**STAFF REPORT 03-16-2022 MEETING**

**APPLICATION NUMBER: 21-7696**

**ADDRESS: 1705 SIXTH**

**SCOPE: ERECT ADDITION, REPLACE WINDOWS**

*Rendering of proposed garage/addition (right) on-site, view to southwest from street, from applicant's submission.*

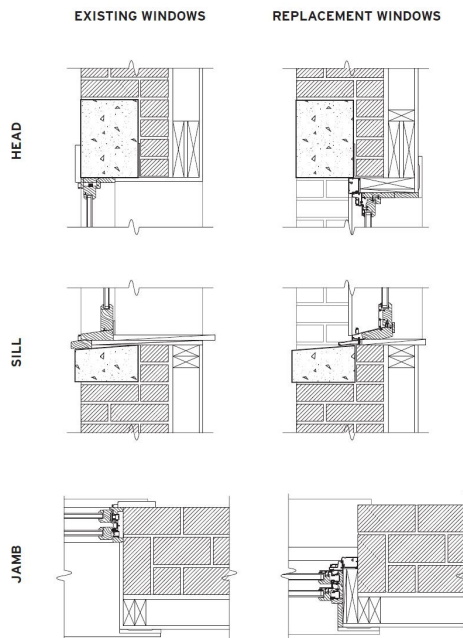
- The northern “bookend” wall, with its Flemish bond brick pattern, strongly vertical nature, and open screen element, is reminiscent of successful 20<sup>th</sup> century modern brick interventions in 18<sup>th</sup> century neighborhoods in historic east coast cities (e.g., Society Hill, Philadelphia, among others). The wall forms a convincing and satisfactory end piece to the linear expansion of the historic building.

- The windows throughout *both* the existing building and the addition are proposed to be dark bronze in color. The Commission’s color chart for Federal Revival houses ([color system C](#)) suggests that yellowish-white is the preferred trim color, and that windows should match the trim (window sash can also be black). The doorway trim in the application is proposed as white. Staff recommends that the windows on the historic building match the white of the door, which should be a classical (off-white) tone, not bright white. Along with being an appropriate color, white windows on the historic house will help the house assert itself with respect to the newer/subordinate addition and its richer/darker finish tones. A bold door color, already dark blue, is appropriate for the historic house. Staff finds that the proposed modifications to window/door openings at the north elevation are appropriate.

- The proposed siding for the addition is Hardie board cementitious siding. As part of a new building/distinct addition on a historic property, staff finds this product to be appropriate. The “deep

ocean” color is a bold choice, but in reviewing photos of other installations the color is not quite as vibrant as it might appear from the applicant renderings; it carries a tone of dark gray in it. See applicant photo on page HDC-24. Staff is satisfied with the color choice in this composition, particularly given the cumulative effect of the project as a whole, including the brick parapet wall, which (as discussed above) grounds the composition historically. Shades of blue have also been successfully used in other comparable historic districts.

- Staff finds that the proposed addition, while large, nevertheless meets the Standards and Guidelines relevant to additions, in that it is sensitively designed to be true to its own era while preserving the massing, expression, and distinctive historic materiality of the original building. The elements composing the addition, including pitched roofs, dormers, and brick walls designed in a contemporary manner, are respectful to their historic precedents without attempting to become facsimiles or create a false sense of historical development.

- Window finish color be revised to match the door trim, both to be a yellowish-white (“classical white”) consistent with the recommendations made in Color System C and acceptable to staff
- Windows should incorporate authentic divided lites, or at least simulated divided lites with spacers.
